AMENDMENT OF SOLICITATION/MODIFICATION OF CONTRACT

A. This Amendment No. 001 is issued to the above referenced Solicitation Number to include a list of attendees who were present at the pre-proposal meeting/site visit conducted on February 16, 2006, provide additional information regarding “Radial Curb Lengths” for Area 1 (Base Bid), Area 7 (Option 1), and Area 8 (Option 2), and provide additional detail for the sidewalks on Constitution Avenue.

Replacement of Sidewalks at the U.S. Capitol Complex, Washington, D.C.
RFP No. 060083

Radial Curb Lengths

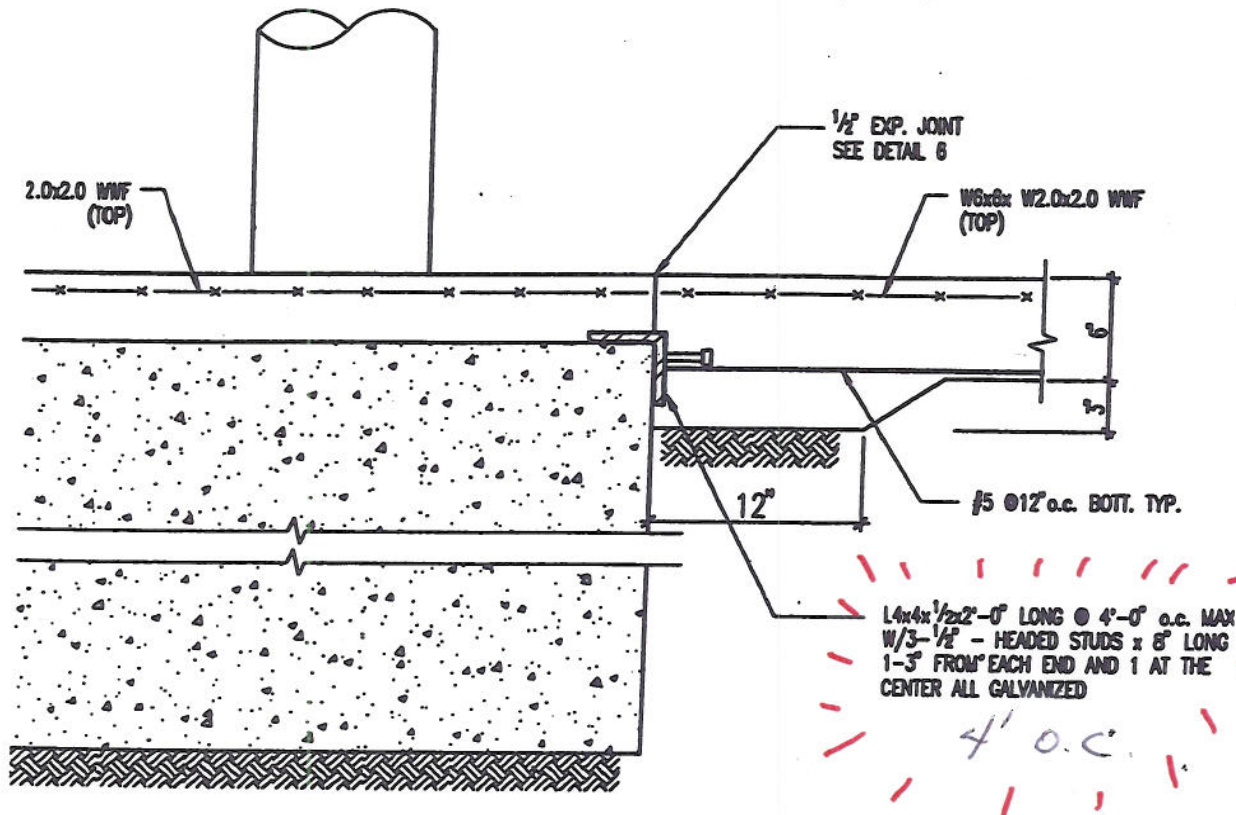
Area 1 (Base Bid): +/- 125 linear feet of radial curb

Area 7 (Option 1): +/- 65 linear feet of radial curb

Area 8 (Option 2): +/- 28 linear feet of radial curb
